SUBJECT: C814-05-0213 - Loop 1 at U.S. Highway 290 West PUD - Conduct a public hearing and approve an ordinance amending Chapter 25-2 of the Austin City Code by rezoning property locally known as 5009 U.S. Highway 290 West (Tract 1) and 4929 Davis Lane & 5000 W. Slaughter Lane from community commercial (GR) district zoning and rural residence (RR) district zoning for Tract 1; community commercial-conditional overlay (GR-CO) combining district zoning for Tract 2, to planned unit development (PUD) district zoning for Tracts 1 and 2. These properties, located within the Barton Springs Zone, have been proposed for a zoning change; the change will result in an amendment to the application of Chapter 25-8, Article 12, (Save our Springs Initiative) to the properties. Planning Commission Recommendation: To grant planned unit development (PUD) district zoning. Zoning and Platting Commission Recommendation: To be considered on February 14, 2006. Applicant: Wilmington Trust #2133 c/o Wal-Mart Stores, Inc.; S.R. Ridge Limited Partnership. Agent: Armbrust & Brown (Richard Suttle, Jr.). City Staff: Jerry Rusthoven, 974-3207.

ZONING CHANGE REVIEW SHEET

CASE: C814-05-0213

NAME & NUMBER OF PROJE

LOCATION MAP
(NOT TO SCALE)

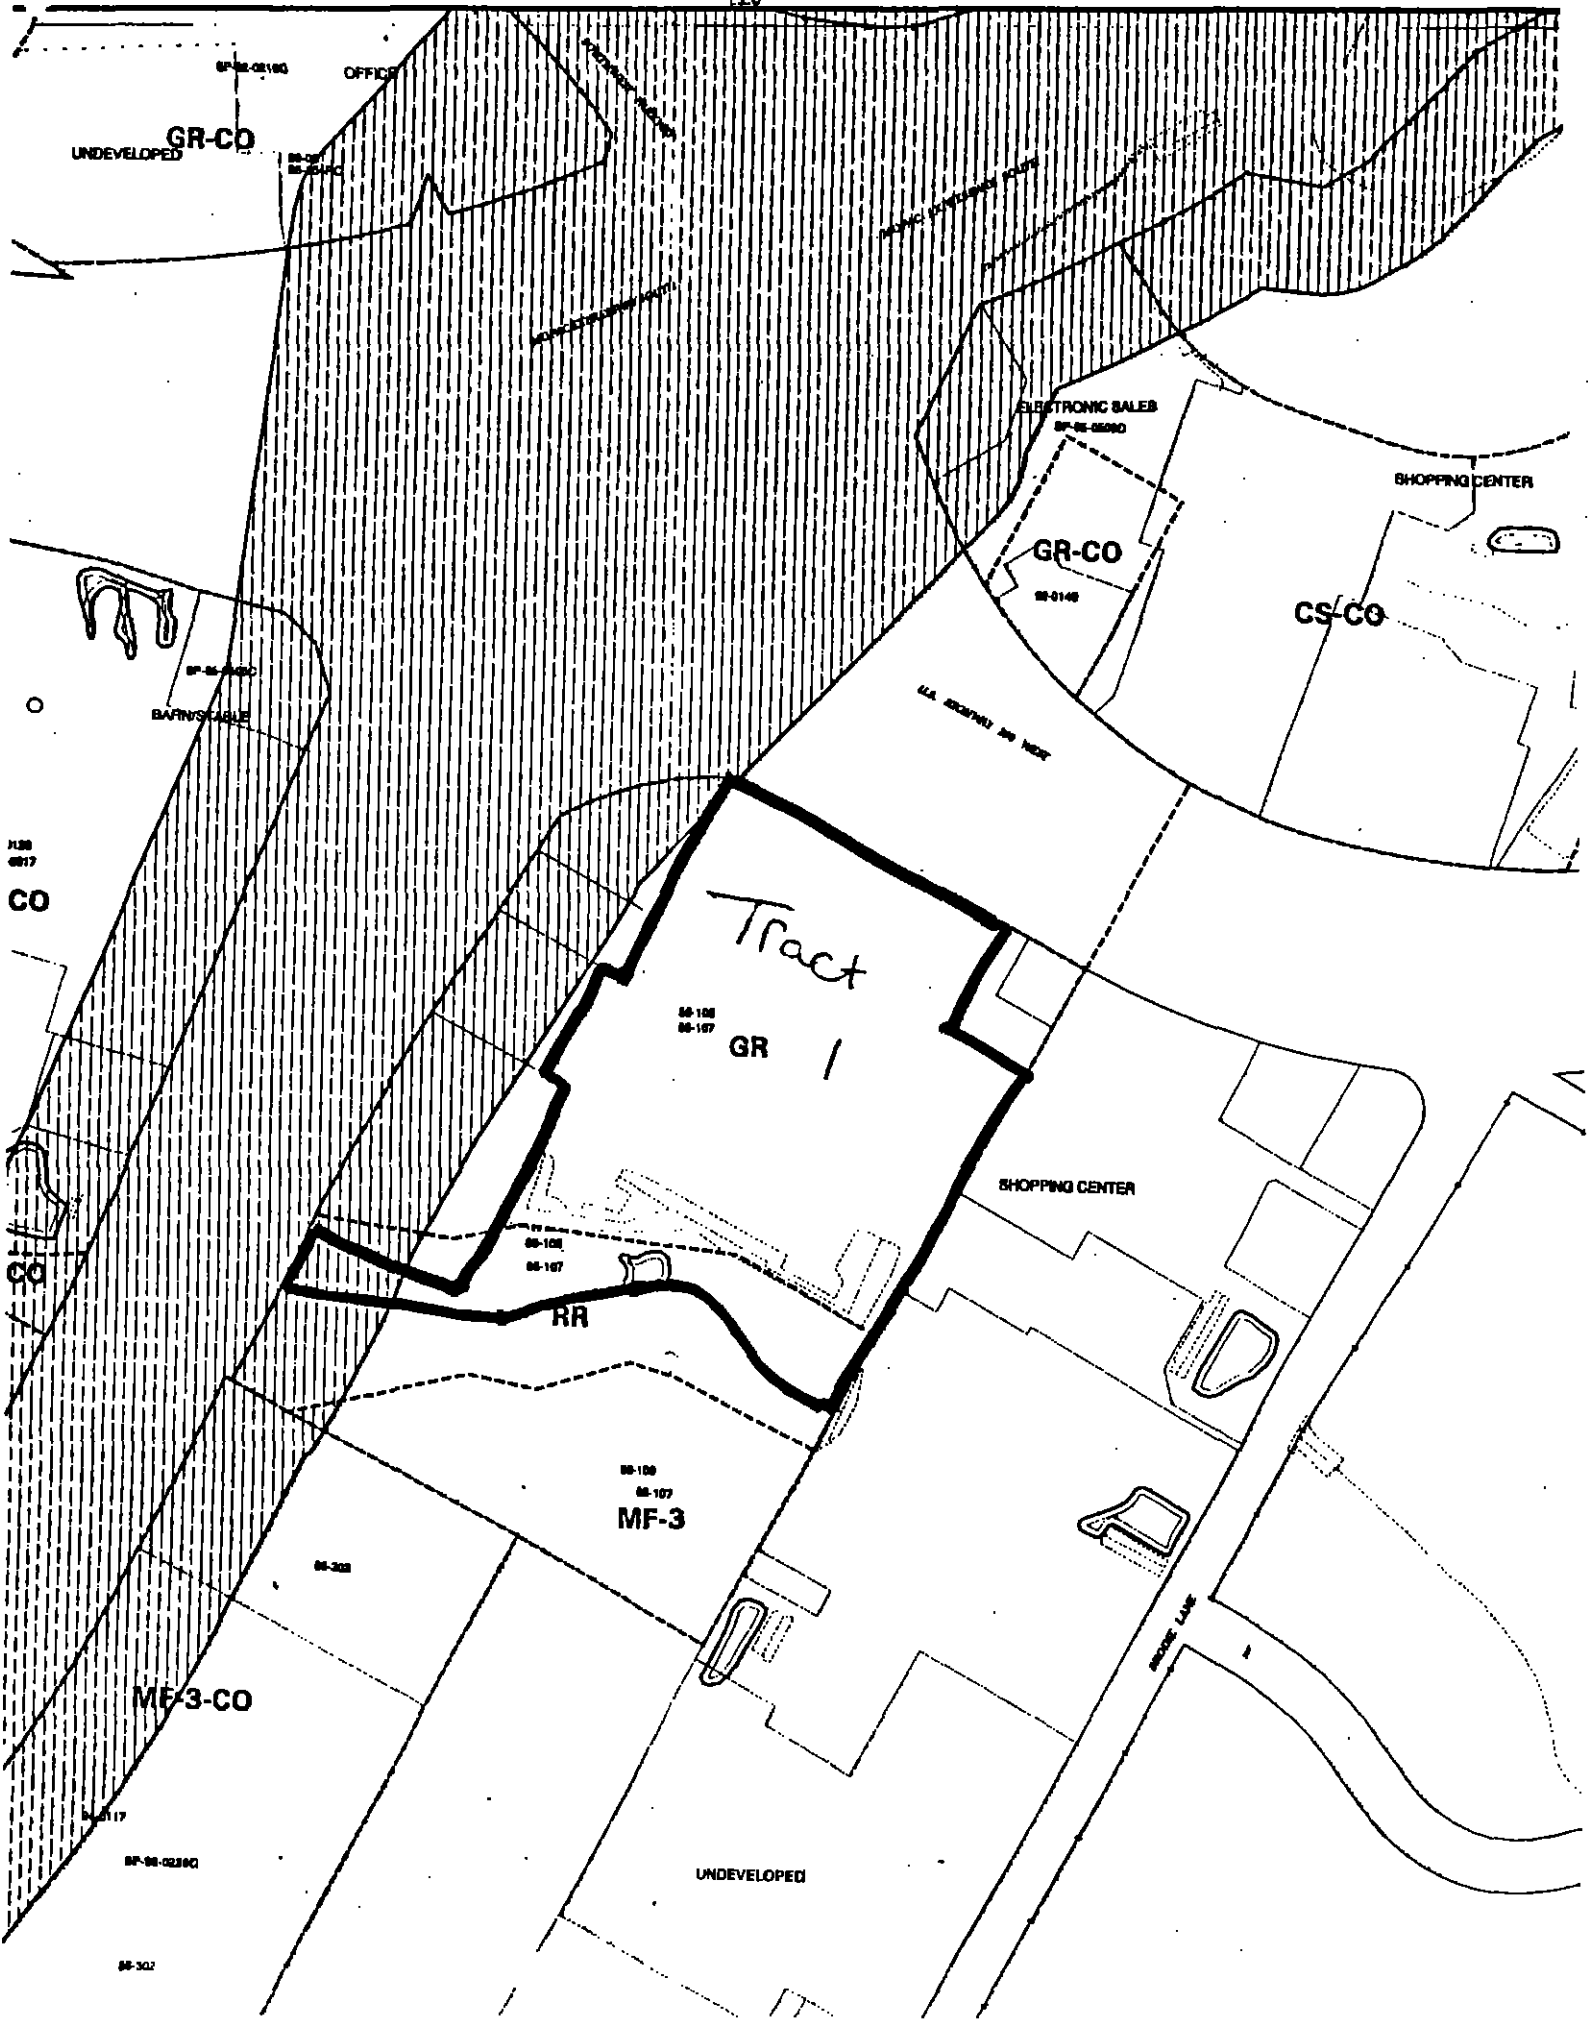
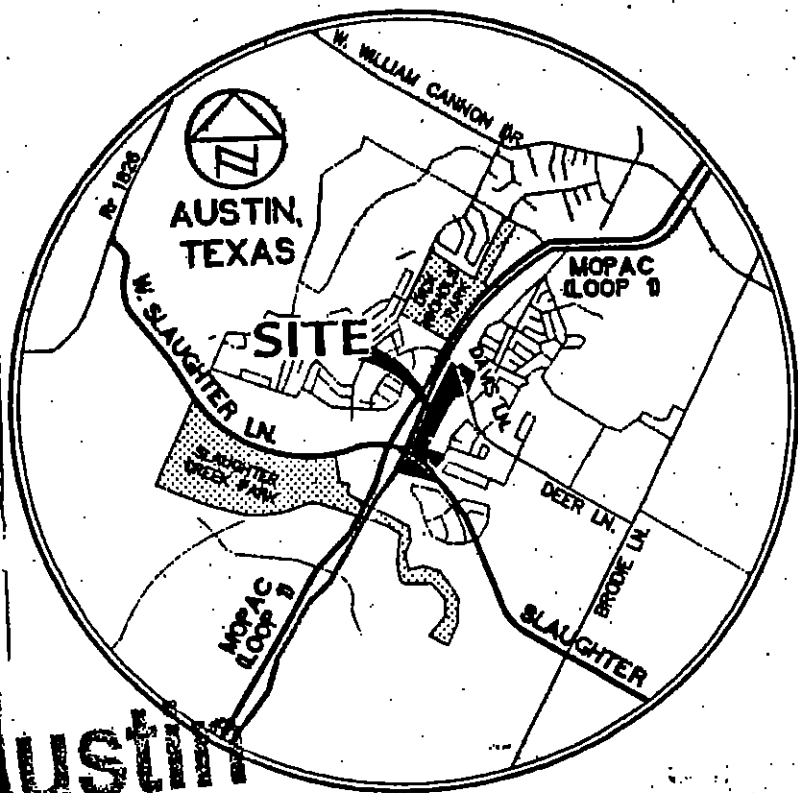
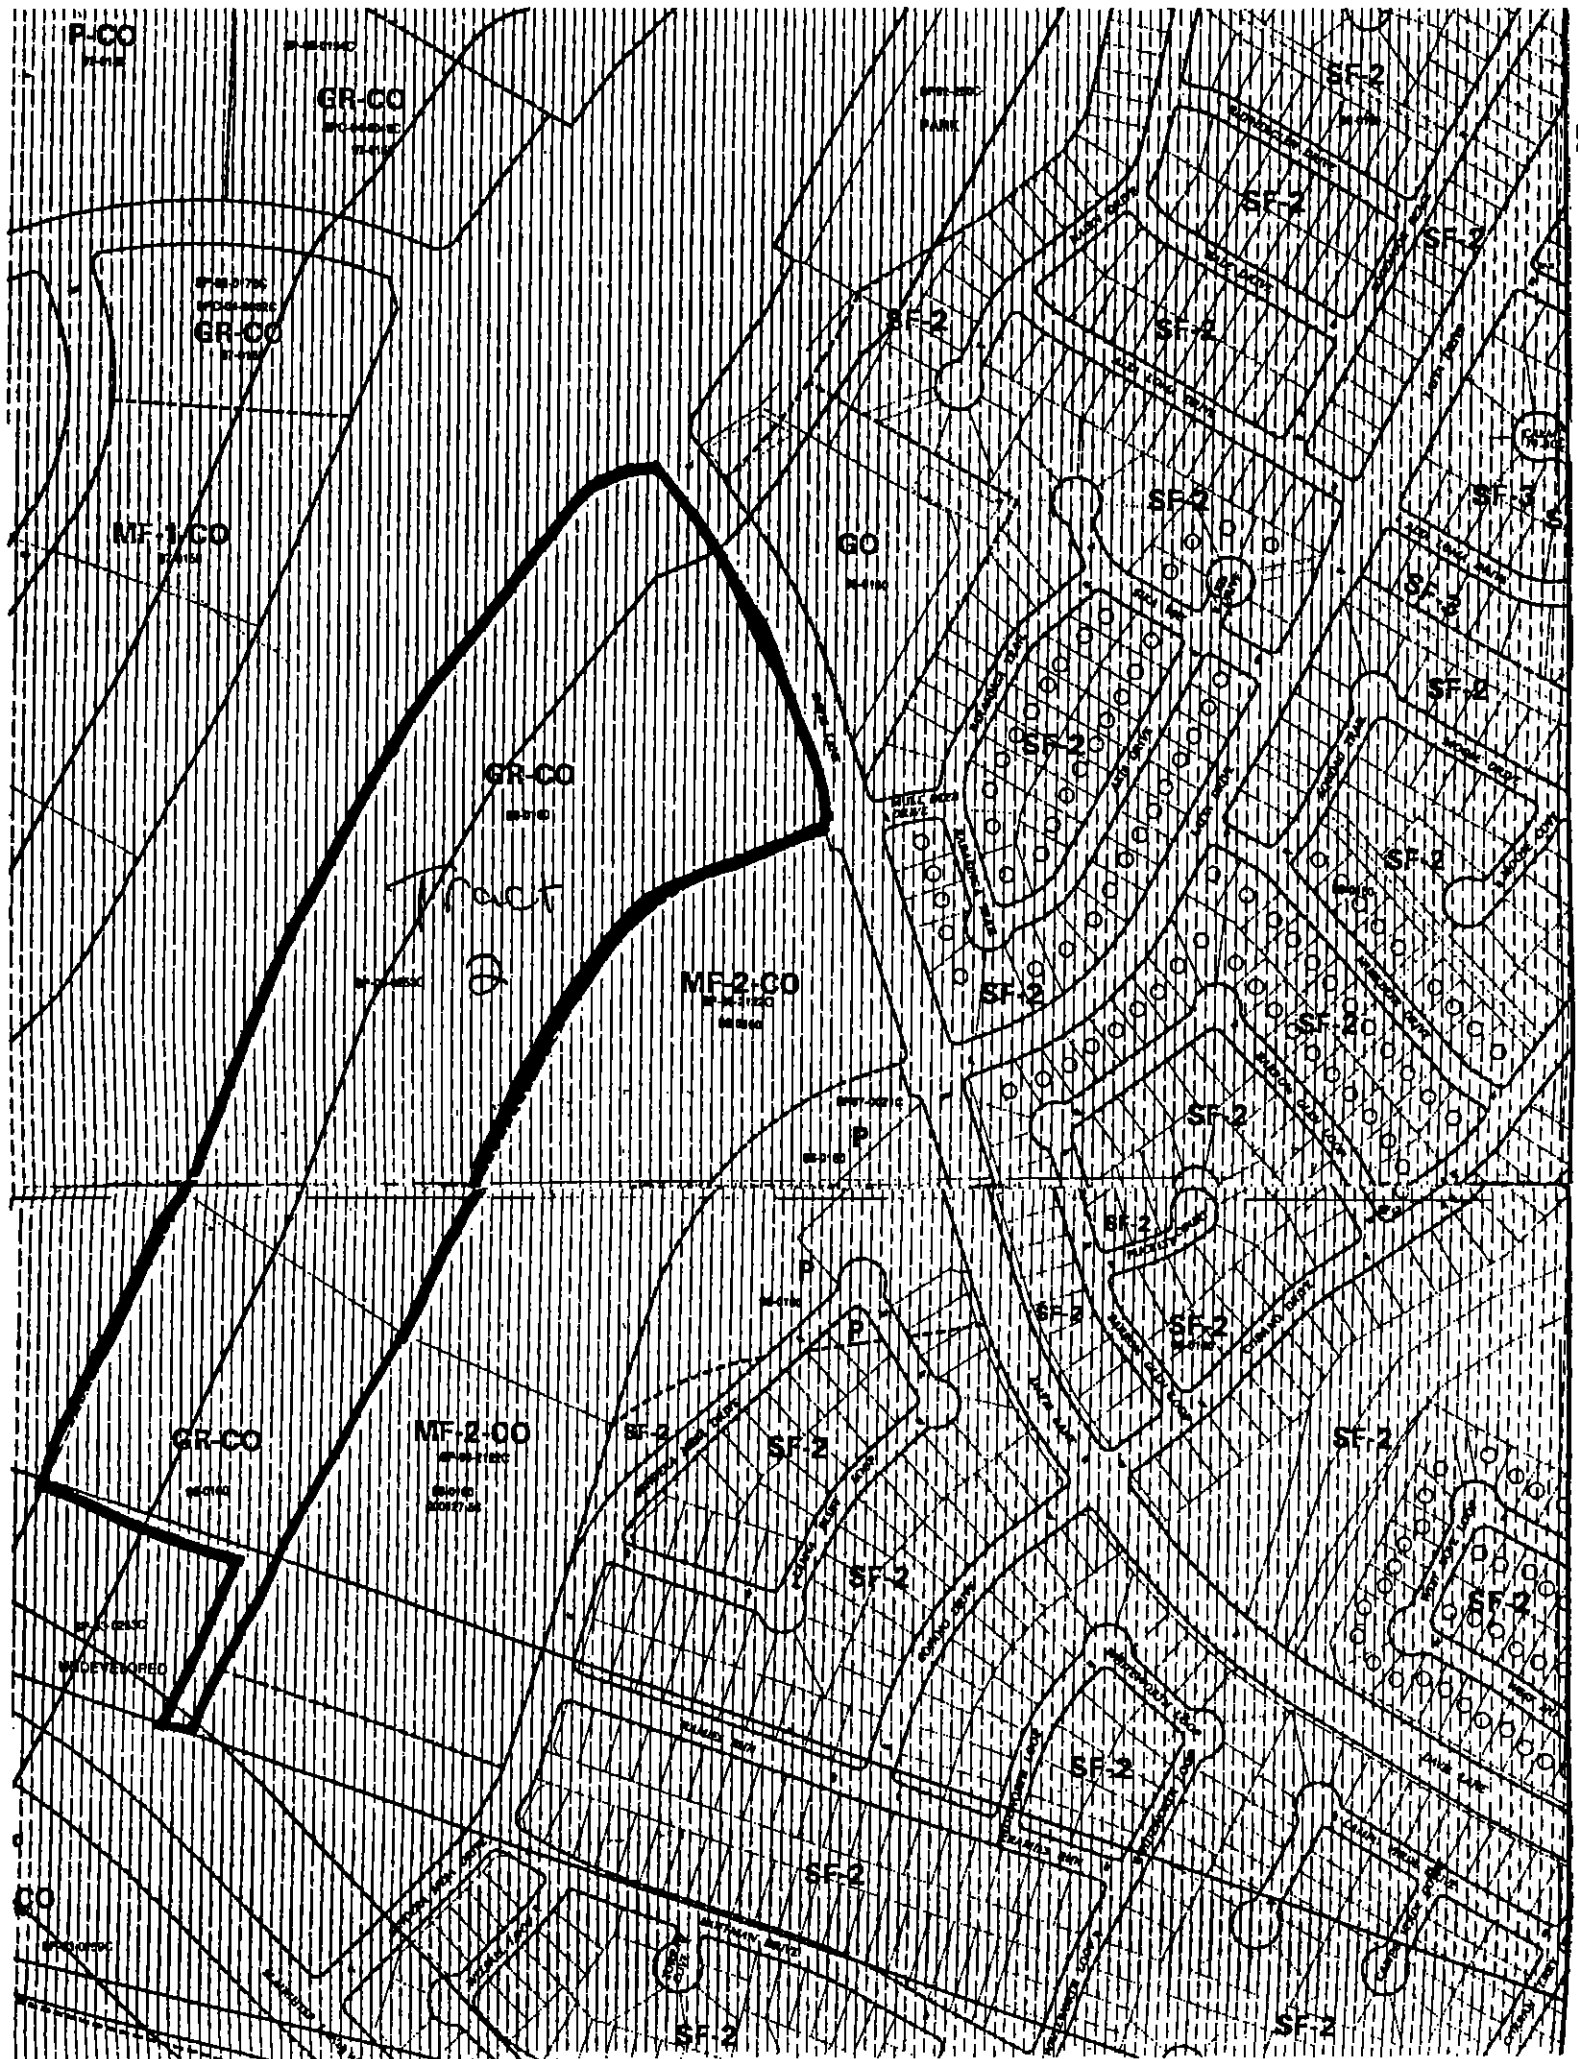
WQ 1. Provide contour call-outs for the PUD Land Use Plan exhibit which was submitted.

DC 1. Please add contour call-outs to exhibit.
